**LANDOWNER SUBMISSION: CASEY FIELDS SOUTH (EMPLOYMENT) & DEVON MEADOWS PSP  
 235 CLYDE-FIVE WAYS ROAD, CLYDE 3978 (PARCEL CF-23)  
 1665 SOUTH GIPPSLAND HIGHWAY, CRANBOURNE EAST 3977 (PARCEL CF-13)  
 TITLE DETAILS: LOT 1 ON PS421555E & CP165660**

**LANDOWNER DRAINAGE SUBMISSION: CASEY FIELDS SOUTH (EMPLOYMENT) & DEVON MEADOWS PSP  
235 CLYDE-FIVE WAYS ROAD, CLYDE 3978 (PARCEL CF-23)  
1665 SOUTH GIPPSLAND HIGHWAY, CRANBOURNE EAST 3977 (PARCEL CF-13)  
TITLE DETAILS: LOT 1 ON PS421555E & CP165660**

**2) Comments on the GHD Preliminary Concept Drainage Strategy report dated 21<sup>st</sup> February 2025:**

Figure 2: Galileo proposal to rationalise Retarding Basins CF-RB-02 and CF-RB-05

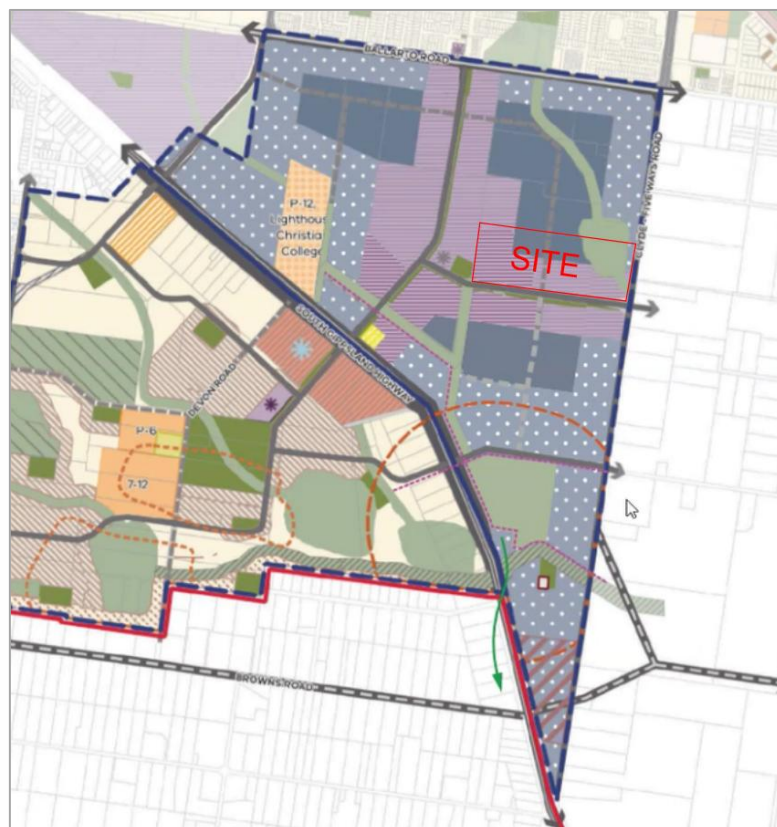
- a) MPG is supportive of Galileo's proposal shown in Figure 2 below, which shows the full removal of SFC2/CF-RB-02 from the subject land. MPV's view is that Galileo's proposal, in the form shown in Figure 2, rationalises the drainage assets and increases the development potential of the overall precinct. Additionally, Galileo's proposal addresses some of the MPG concerns outlined in item 4 above regarding retarding basins CFS2/CF-RB-02 and CSF4/CF-RB-05.
